## PLANNING AND ZONING COMMISSION MEMORANDUM

**SUBJECT:** ZC21-0004 Public hearing and consideration of a request from TRC Architects for a zoning change from C-1 (Commercial) and R-7-MF (Multifamily) to NR-PD (Nonresidential Planned Development) at 3918-3920 Rufe Snow Drive and 3917-3921 Flory Street, being 1.04 acres described as Lots 5B1, 5C1, 8A, and 8B, Block 1, Jack M. Estes Subdivision.

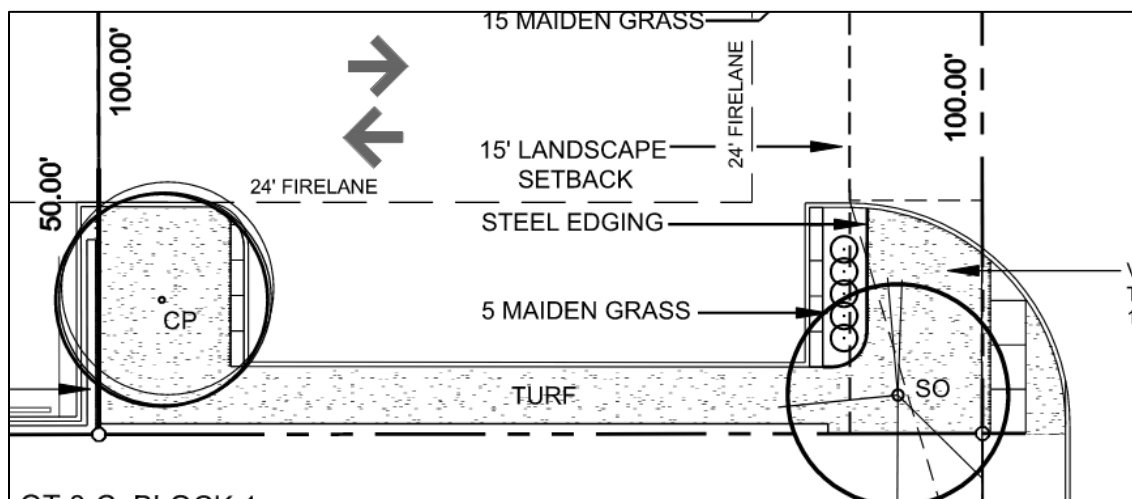
While Lot 3 would provide over 23% landscaped area, the owner proposes a six foot wide buffer yard adjacent to most of the south property line. This narrower buffer yard is proposed to accommodate an area for parking spaces (see exhibit below). Two trees are proposed, and a six-foot tall masonry screening wall would be constructed on the entire length of the property line.

Since the adjacent property is zoned for residential use, a 15-foot buffer yard is required. The buffer yard must include one large tree per 30 linear feet, with at least 40% of the trees being an evergreen species. Based on the length of the buffer yard, three trees are required. In addition to the two proposed trees, the Development Review Committee recommends that three additional ornamental trees be planted within the buffer yard. This recommendation is included in the attached NR-PD standards.

Approve ZC21-0004, subject to three additional ornamental evergreen trees being provided adjacent to 3915 Flory Street.
